DECISION N°: WEC_2022_D0024_All_Fuel_rig

SUBJECT: Update of the autonomous tank installation

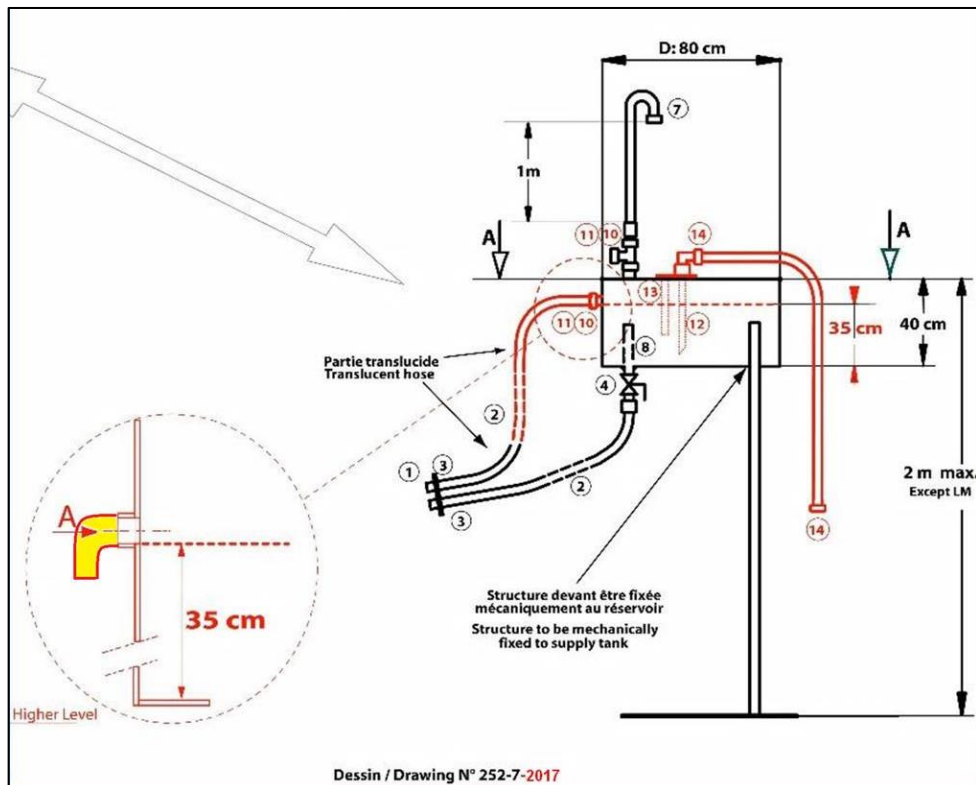
In order to accommodate installation of the autonomous tank in Le Mans, it will be required to install a 90° elbow in position 10 on drawing 252-7 of the LMP2 Technical Regulations, and drawing 7.A of the Le Mans Hypercar and LMGTE Technical Regulations, as defined below:
